THE UNIVERSITY OF NORTH CAROLINA
AT
CHAPEL HILL

The University proposes the following Amendment to the Development Plan Modification #1 submitted to the Town on April 3, 2003 and the subsequent Addendum #1 submitted on May 23, 2003. The two projects are: the parking deck at Jackson Circle and parking deck and chiller plant near Cobb Dormitory. The University intends to submit this material for entry into the record of the hearing on Monday, August 25, 2003.

The University of North Carolina at Chapel Hill
Amendment to Development Plan Modification No. 1
August 22, 2003

Re: Northeast Parking Deck/Chiller at UNC-CH, Chapel Hill, Orange County, GS03-1832

6a. Response to Mayor's Committee in August

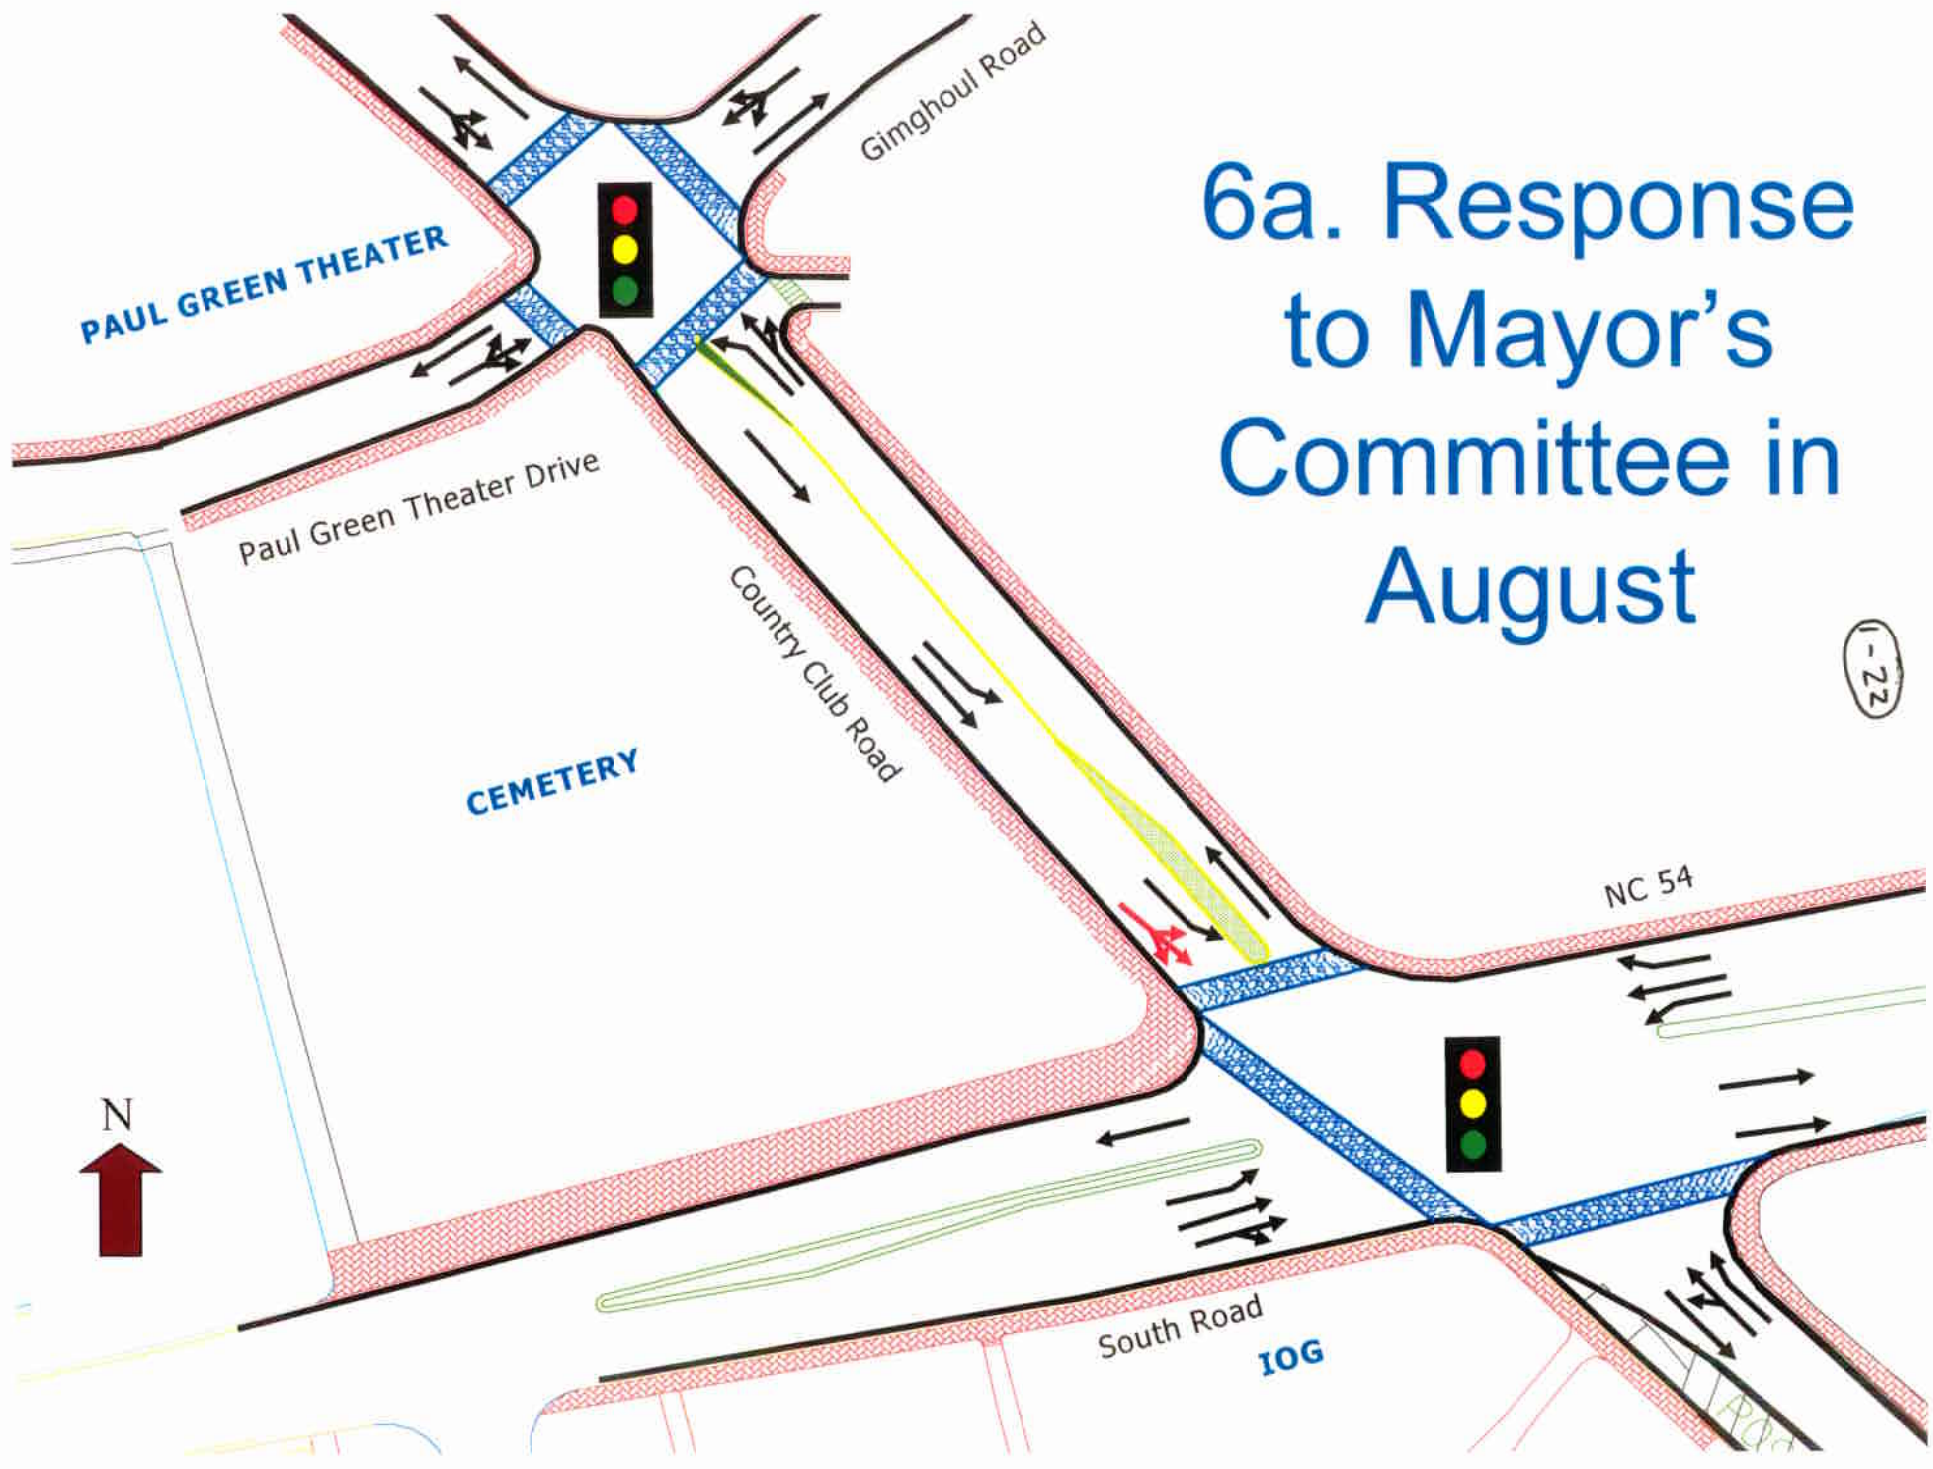
The following improvements are now proposed for Country Club Road:

- Installing a traffic signal at the Paul Green Theater Drive/Gimghoul Road intersection, including pedestrian crossings, pedestrian countdown signal heads and a short, raised island on the south of the intersection.

- Re-striping the road to provide a northbound left-turn lane and southbound left-turn lane at the intersection (no widening is required).
 - Slightly realigning the end of Paul Green Theater drive to better align with Gimghoul Road.

- Changing the southbound lane closest to the curb on Country Club Road on the north side of South Road from a shared through/right-turn lane to a shared left/through/right-turn lane (to provide two lanes for southbound left-turning traffic).

- Adding a short, raised island on Country Club Road on the north side of the South Road intersection (no widening is required).
 - Re-striping Country Club Road on the south side of South Road to add an exclusive right-turn lane (no widening is required).

- Adding a sidewalk on the east side of Country Club Road between Gimghoul Road and South Road.
- **Access to Cemetery:** A metered visitor parking lot is sited west of the Paul Green Theater on Paul Green Drive. The University will make special parking arrangements for funerals and visitors caring for their gravesites. The University agrees to stop noise generating construction activities for funerals during construction of the Chiller Plant and Parking Deck.
